ADDENDUM NO. 2 TO PROJECT NO. 45832

**CONSTRUCTION, ELEVATOR, HVAC, PLUMBING, AND ELECTRICAL WORK
REHABILITATE ELEVATORS
CULTURAL EDUCATION CENTER
EMPIRE STATE PLAZA
ALBANY, NY**

April 12, 2024

DRAWING NUMBER: **U-503**

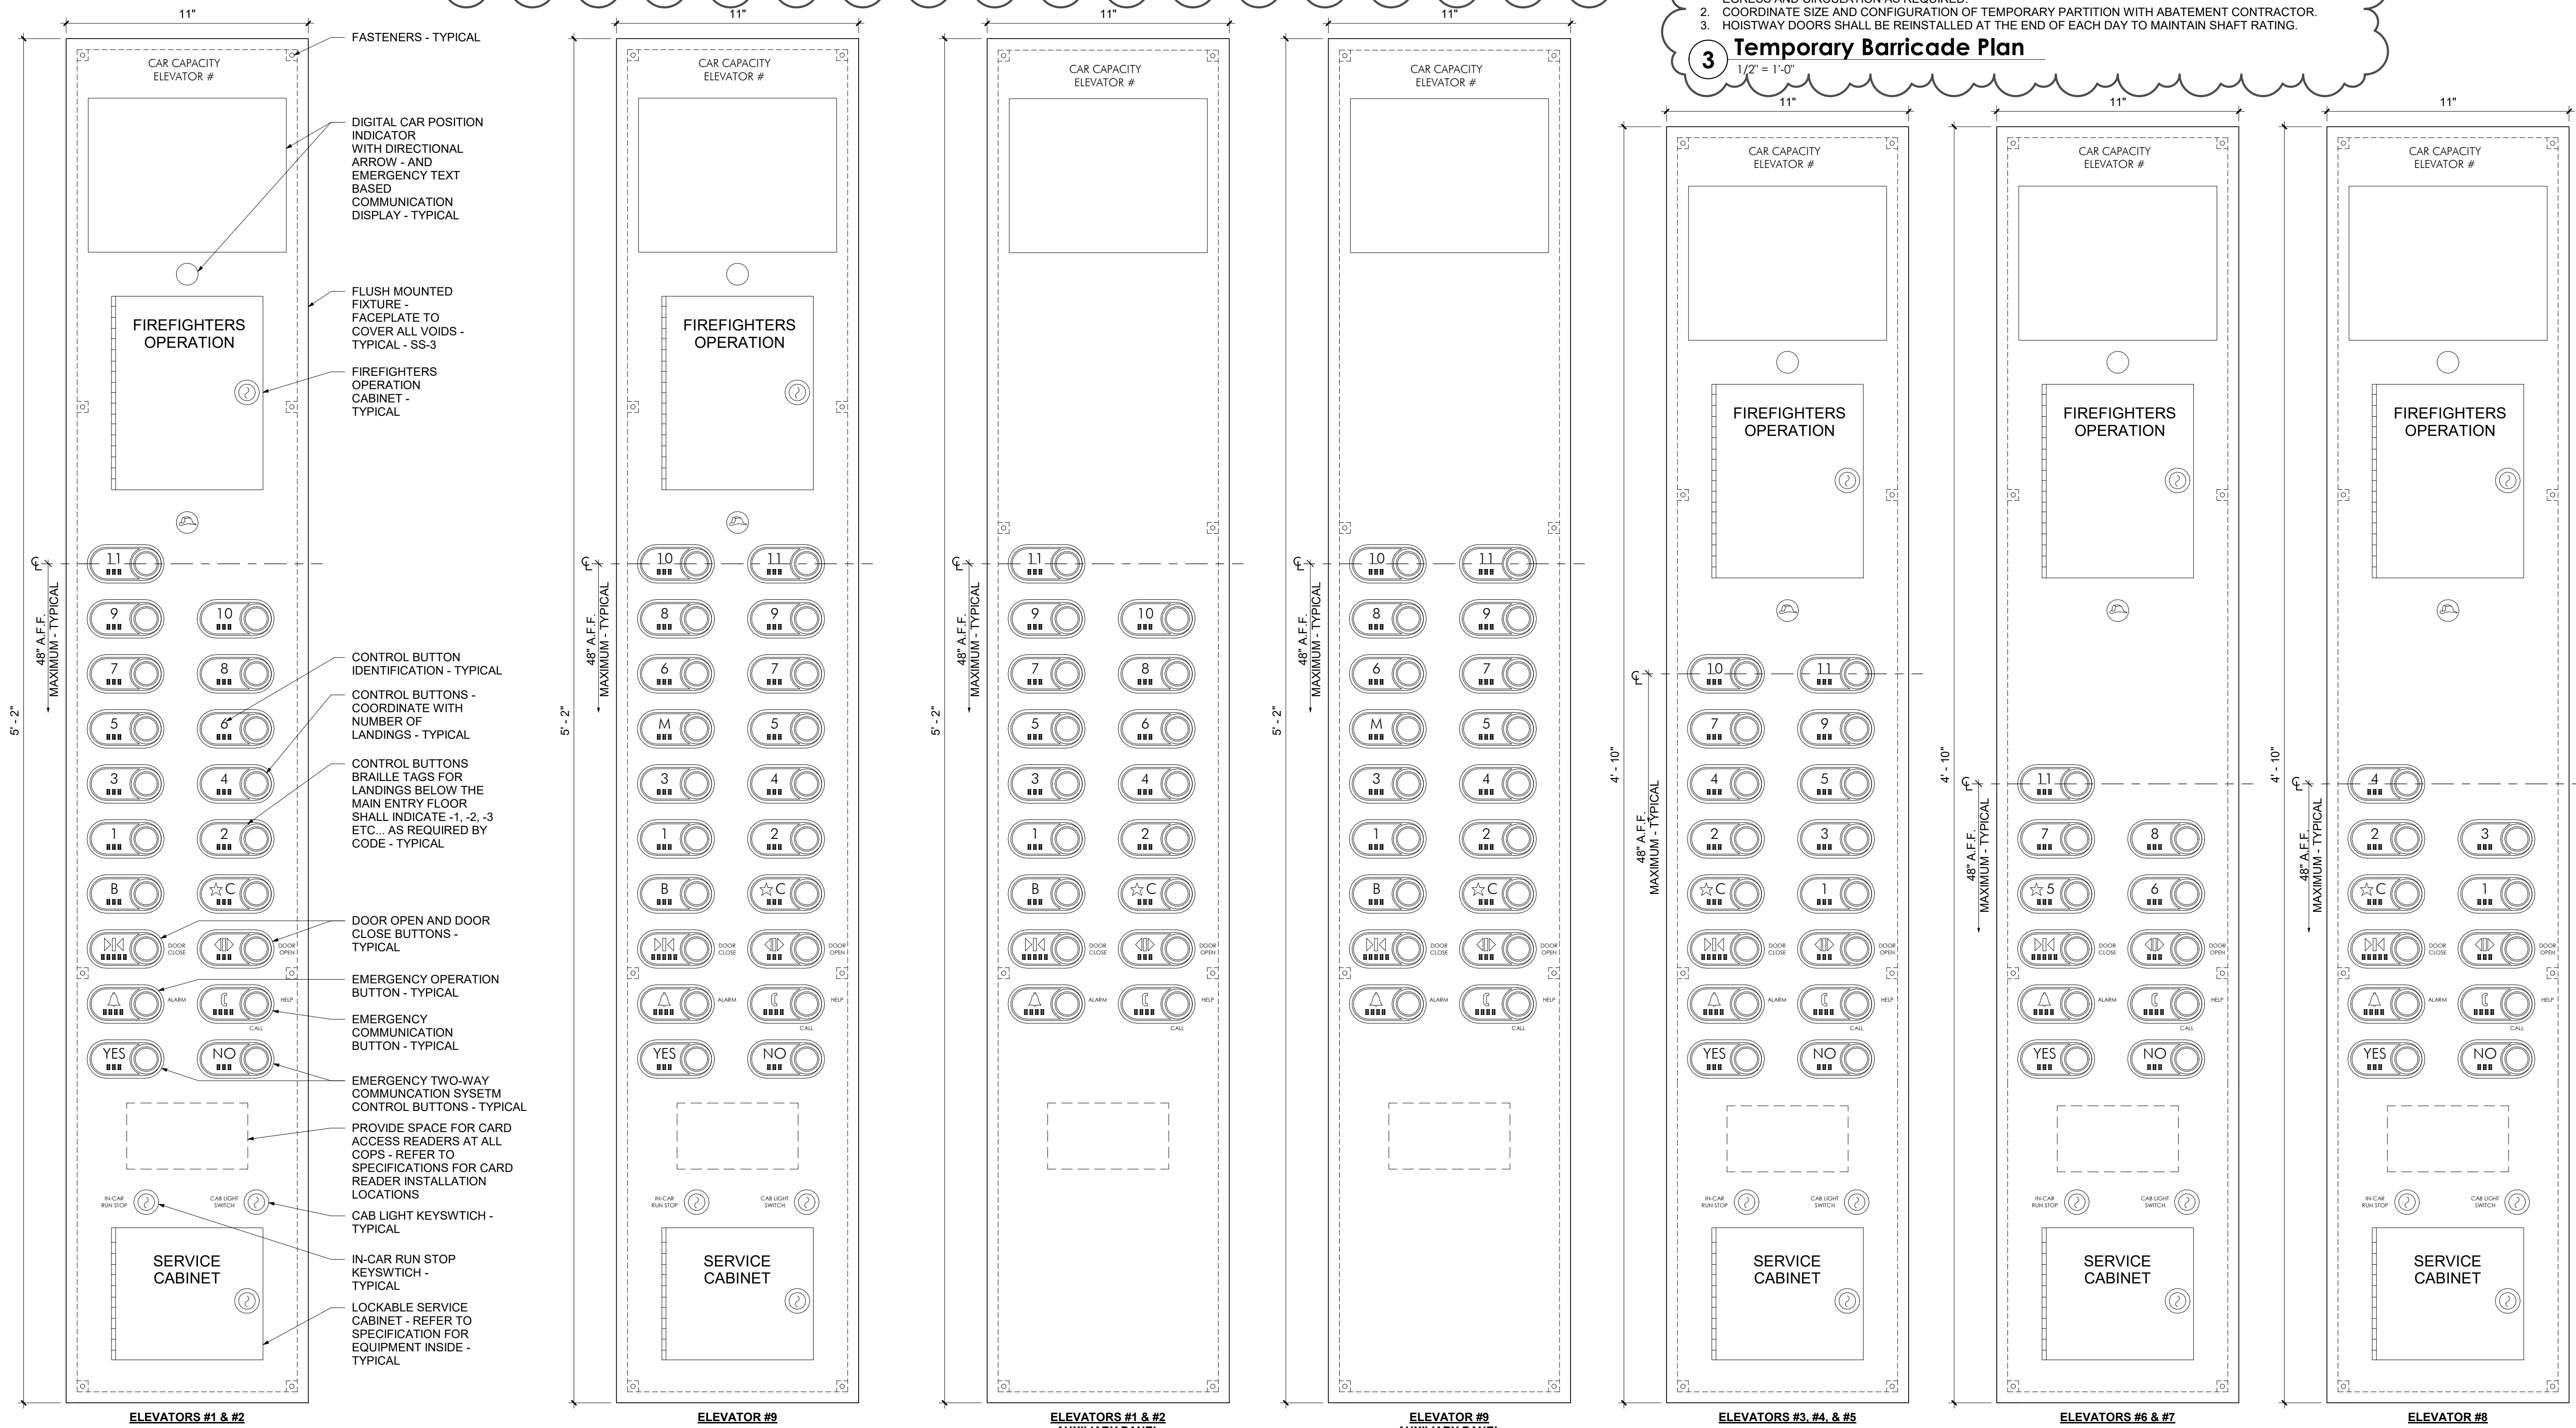
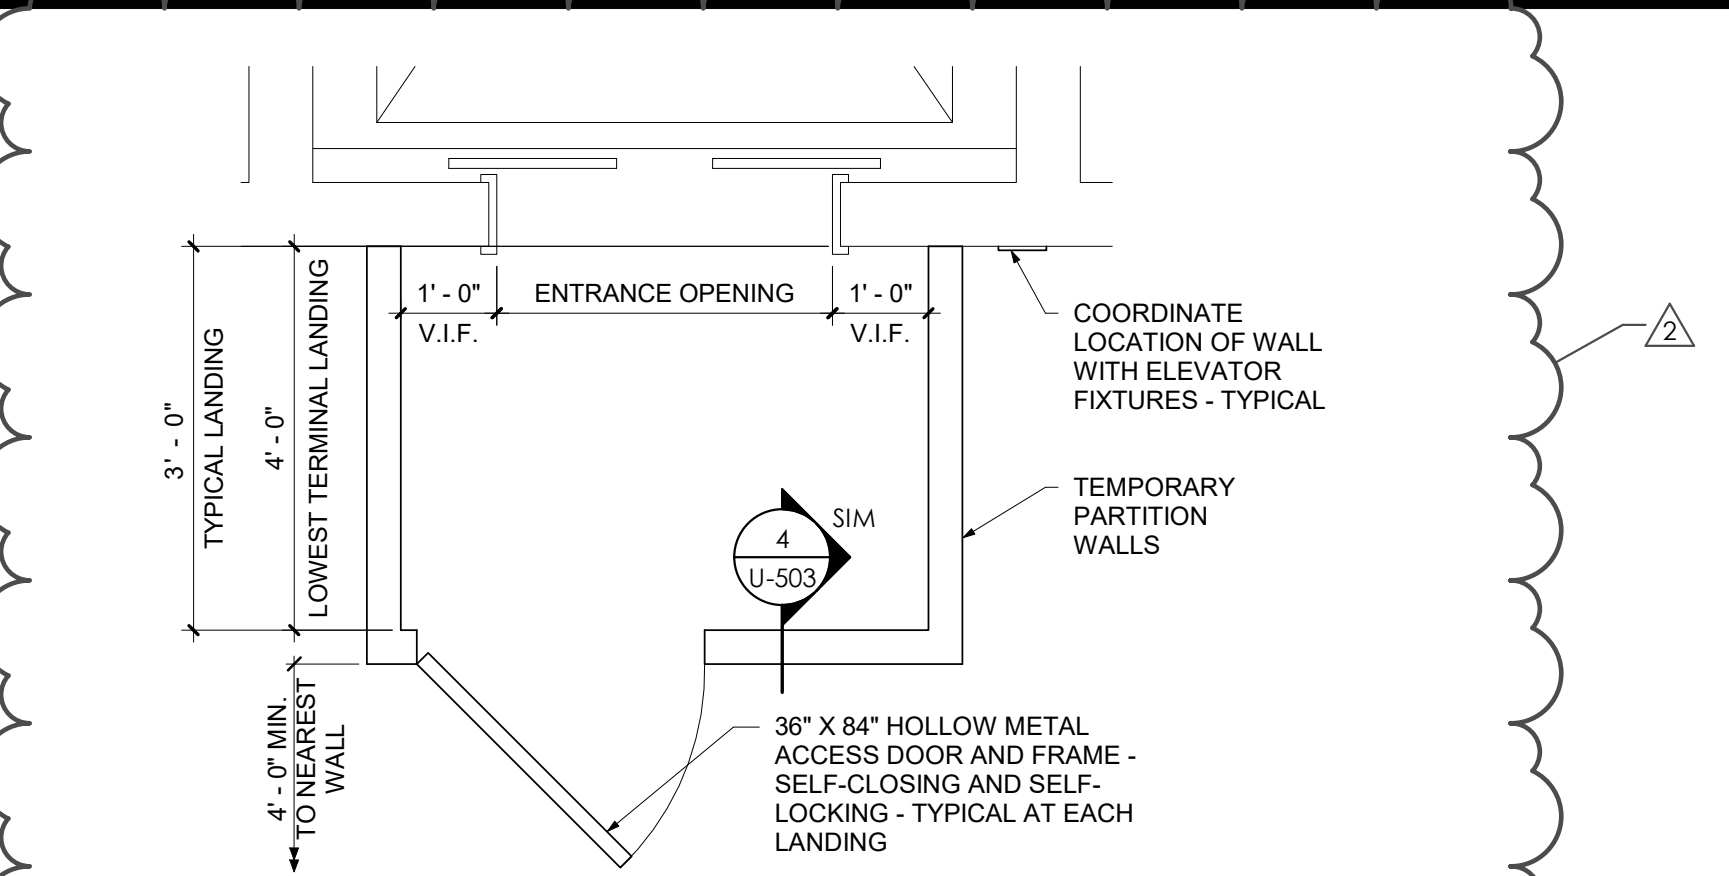
- 13. Drawing No. U-101
 - a. General Notes, Change Note L to Read:
“L. PROVIDE TEMPORARY PARTITIONS AT ELEVATOR ENTRANCES FOR THE PERFORMANCE OF CONTRACT WORK, AS DETAILED ON U-503.”

- 16. Revised Drawing:
 - a. Drawing No. U-503, noted “REVISED DRAWING 4/12/2024” accompanies this Addendum and supersedes the same numbered originally issued drawing.

NOTE:
1. TEMPORARY PARTITION SHALL BE PROVIDED AT EACH LANDING AND AT EACH ELEVATOR FOR DURATION OF CONSTRUCTION UNLESS OTHERWISE COORDINATED WITH OWNER'S REPRESENTATIVE. MAINTAIN BUILDING EGRESS AND CIRCULATION AS REQUIRED.
2. COORDINATE SIZE AND CONFIGURATION OF TEMPORARY PARTITION WITH ABATEMENT CONTRACTOR.
3. HOISTWAY DOORS SHALL BE REINSTALLED AT THE END OF EACH DAY TO MAINTAIN SHAFT RATING.
